# Findings of Fact | Wetland Conditional Use Permit

Property Address: 185-187 Wentworth Road

Application #: LU-25-2

Subject: 185-187 Wentworth Road, Portsmouth, NH  
Wetlands Conditional Use Permit Application (WCUPA) LU-25-2  
Marina Restoration Project

**SHEET 5**

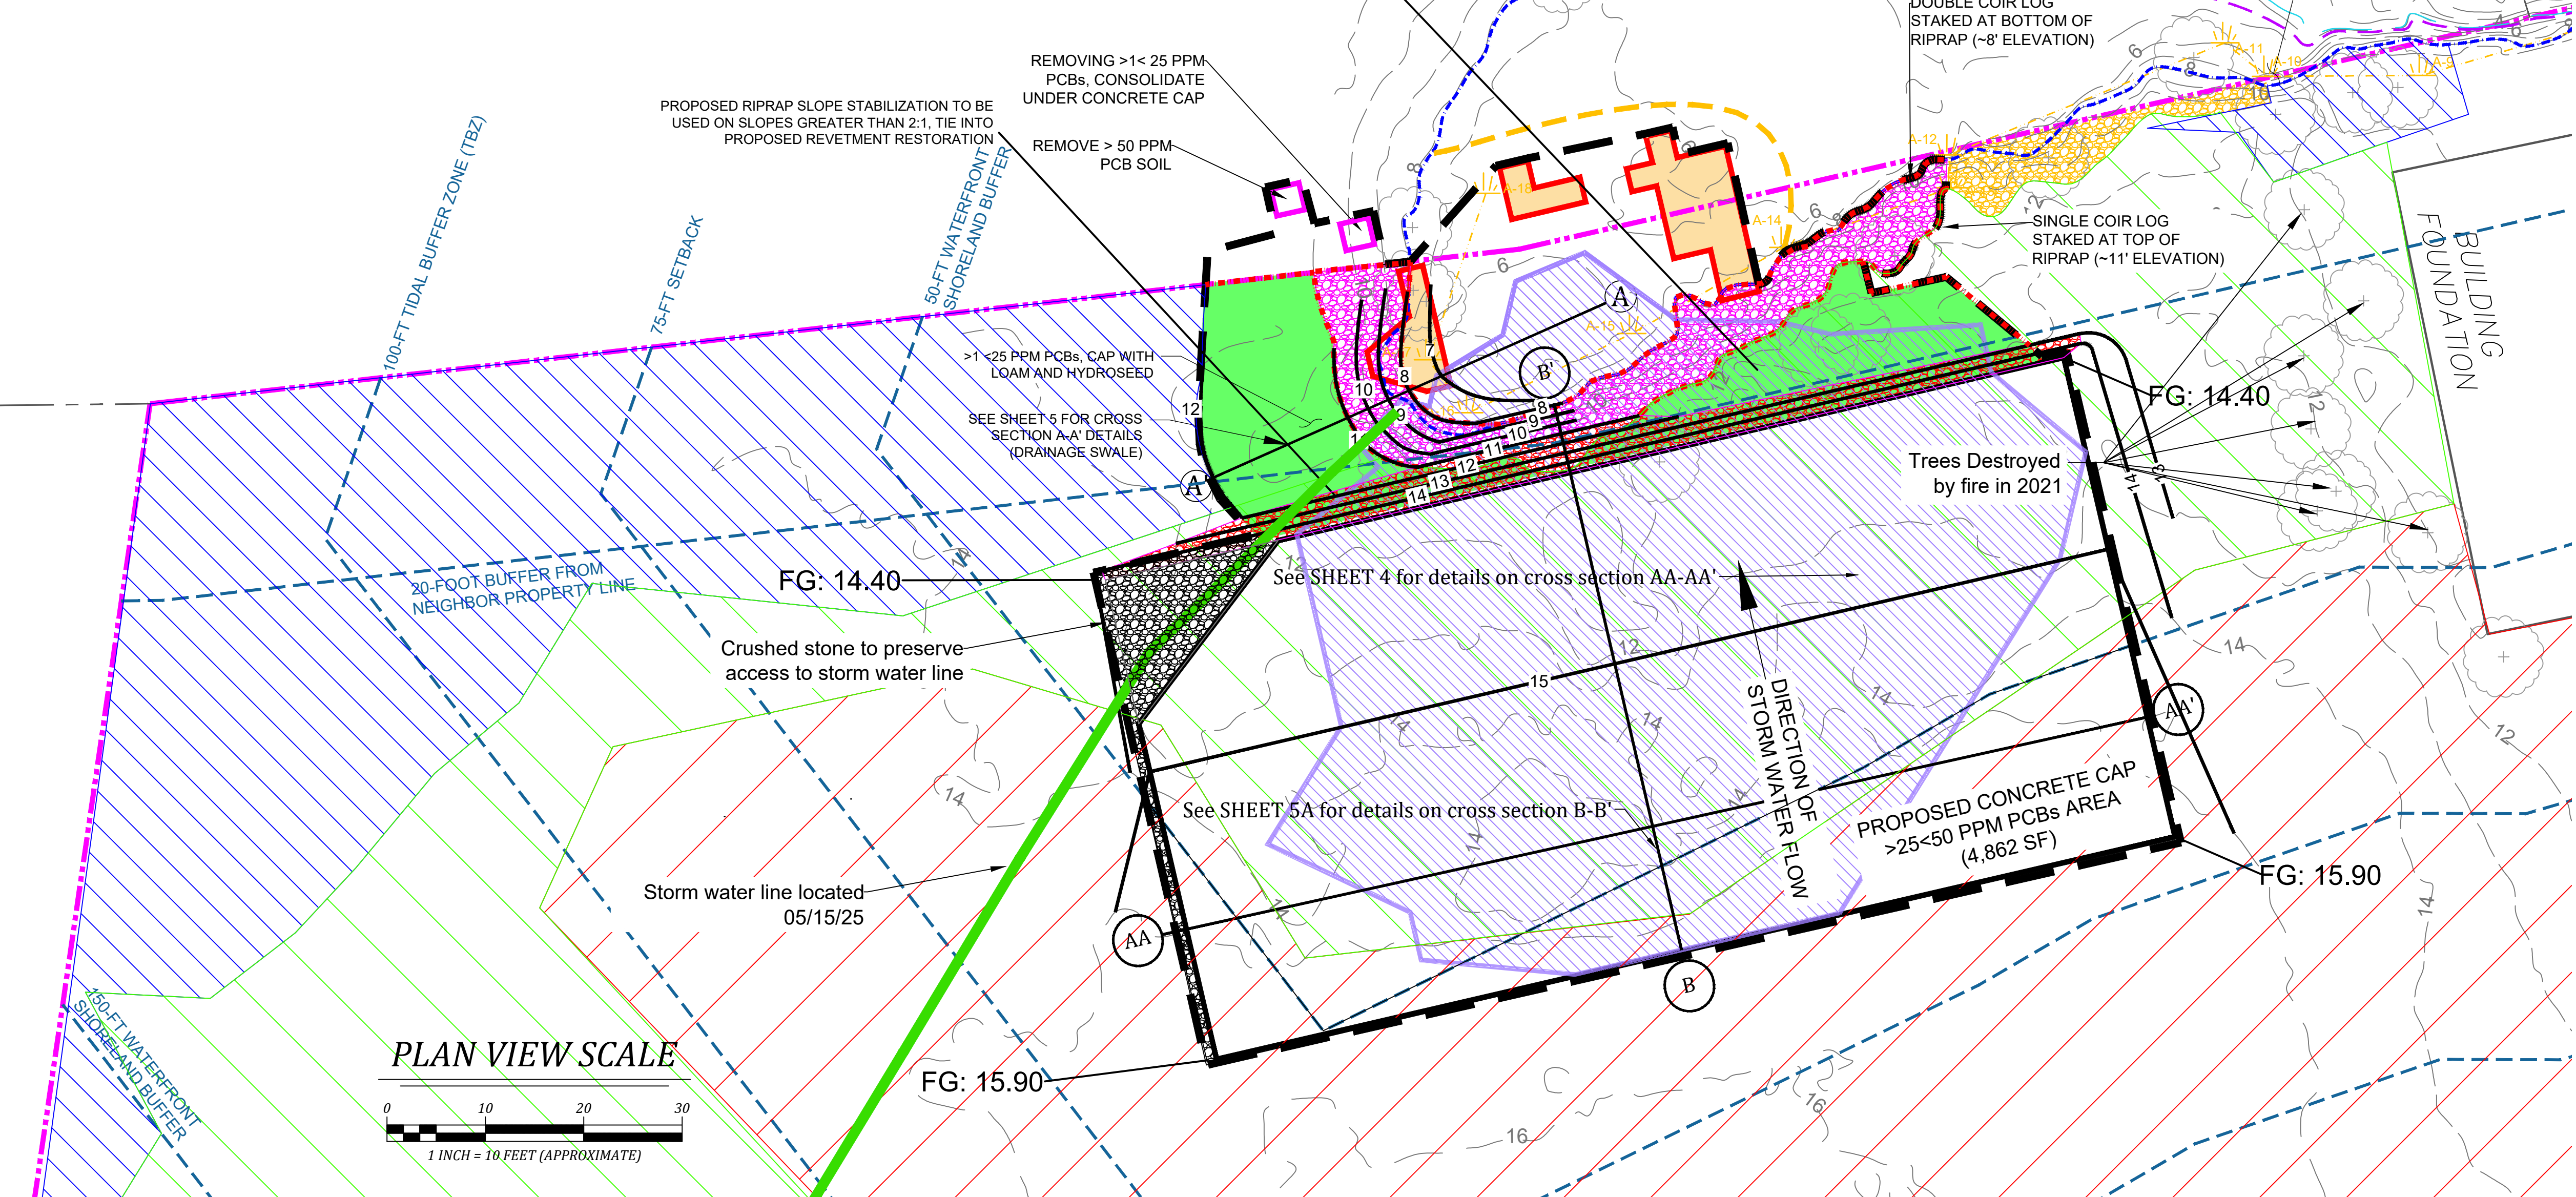
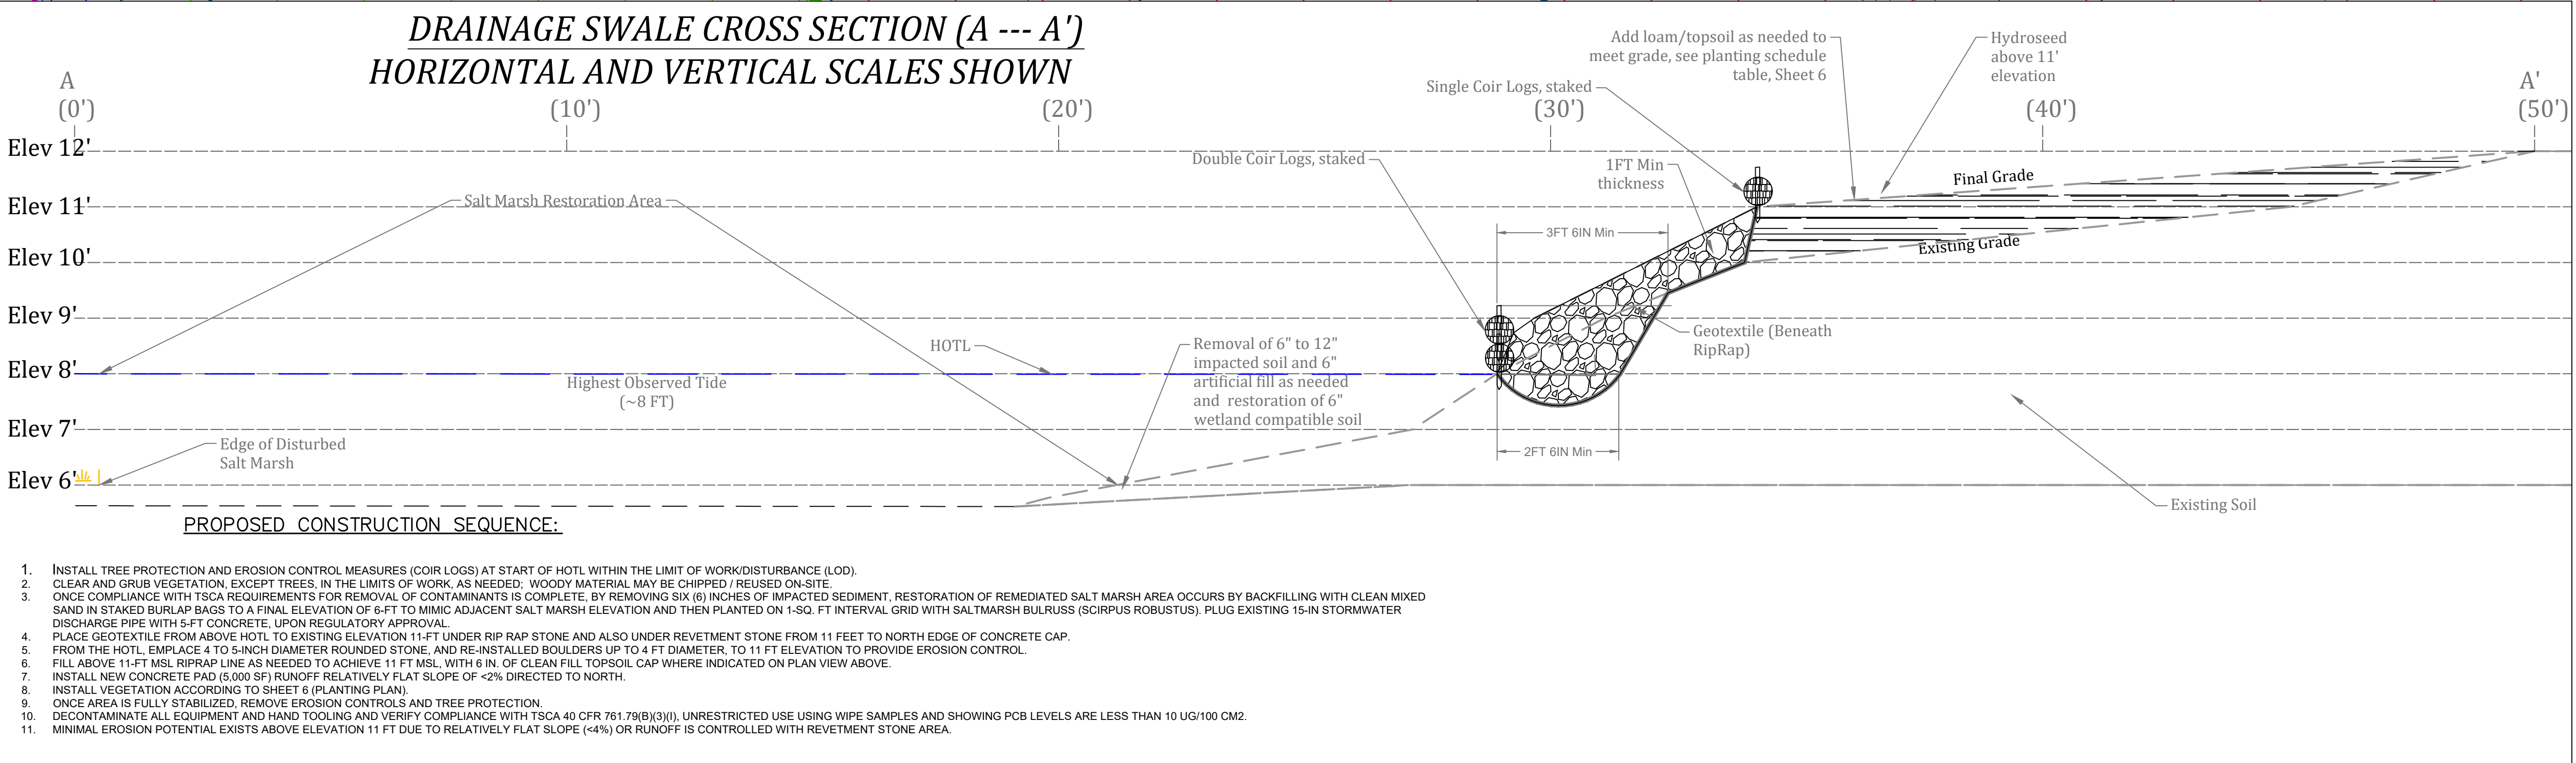
4. **Stipulation No. 4.** Applicant shall clearly delineate on the site plan and provide a detailed description of the proposed grassed swale. This should include dimensions, materials, depth, etc.

4. Applicant shall clearly delineate on the site plan and provide a detailed description of the proposed grassed swale. This should include dimensions, materials, depth, etc.

**Applicant Response:** Revised Engineering Sheet 5, attached to Addendum, reflects this stipulation.

Pg 62 WPA Appendix E, Engineering Project Plans, Drawings & Sheets: Sheet 5 is now replaced, and is attached to this document. It has been changed to address the 4 Stipulations of ConCom's March 14, 2025 Letter and include the location of the existing 15 in diameter drainage pipeline. New Sheet 5A is also attached, which presents a new cross section detail of a portion of Sheet 5's Section B-B'. Note that for any site plan information differing between Sheets 5 and 7, Sheet 5 information will prevail. Both Sheets 5 and 5A have been stamped by the Applicant's NH Professional Engineer.

Project #: 2021-075A File:2021-075A(SS2)06-22
		APRIL 23, 2025
		SHEET 5A

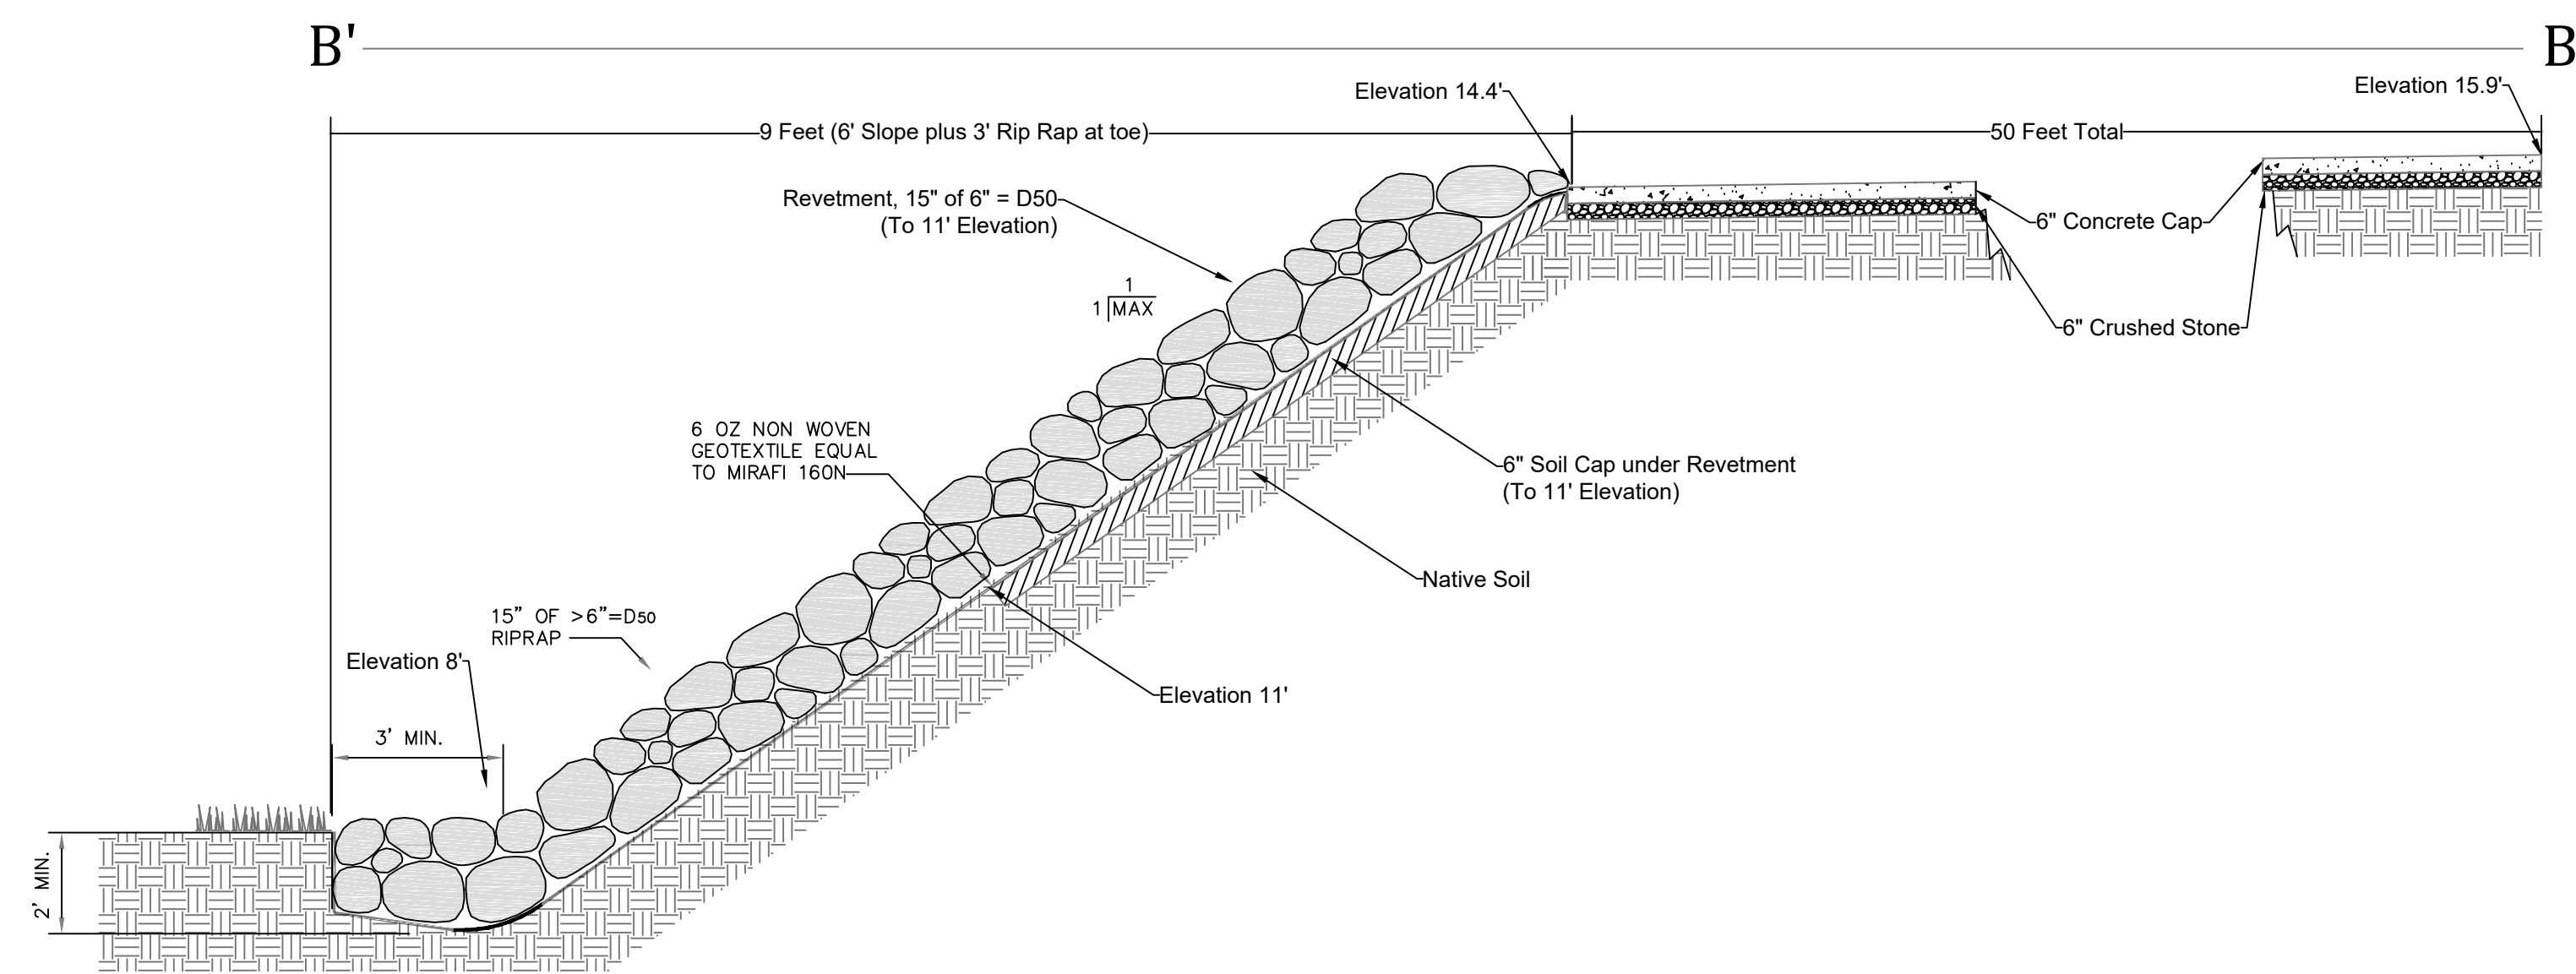
Pg 2 Cover Letter, Page 2, Section 3.0, 2<sup>nd</sup> bullet, AND Pg 11 Wetland Permit Application (WPA) Pg 1, Section 2.0, Project Description, Item 2c; AND Pg 118 WPA Appendix J, Coastal Resource Worksheet, Section 1, Second Paragraph. After first sentence, add:

“Also, 260 SF of the 770 SF level upland graded areas from 11 to 14.5 ft elevation will after 6-inch soil cap installation, be covered by up to 15 inches of revetment, which is an erosion control stone of 6-inch diameter.”
